Ref:	NR/L2/ELP/27009/MOD C65
Issue:	1
Date:	03/12/2011
Compliance date:	03/03/2012
Page	1 of 6

OVERHEAD LINE CAMPAIGN CHANGES – DATA SHEET

RENEW 'KOREAN' STYLE REGISTRATION ARMS IN TUNNEL ASSEMBLIES.

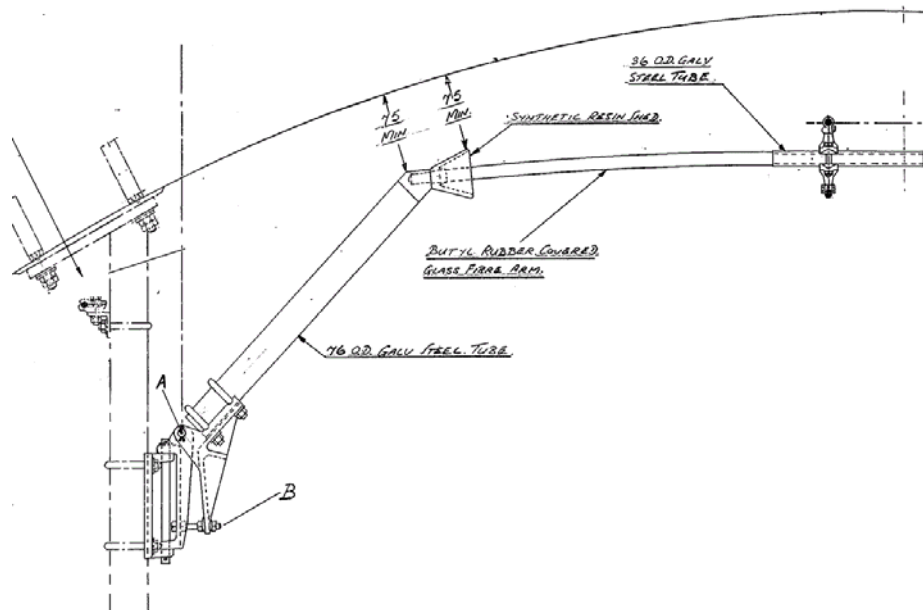
COMPONENT 'Korean' style registration supports in tunnels. These are shown on the following OLEMI drawings:

Component drawings	123/040, 121/040
Assembly drawings	111/017, 111/018, 199/195

PROBLEM The insulation with these supports degrades over time and will lead to 25kV flashover.

OVERHEAD LINE CAMPAIGN CHANGES – DATA SHEET	
65	RENEW 'KOREAN' STYLE REGISTRATION ARMS IN TUNNEL ASSEMBLIES.
ACTION REQUIRED	<ol style="list-style-type: none"> 1. Replace original 'Korean' arm with new replacement. The original arms are obsolete but replacements can be manufactured if required. 2. Replace with Siemens elasticated support arm to OLEMI drawings 1/121/864 or UK1/121/493.
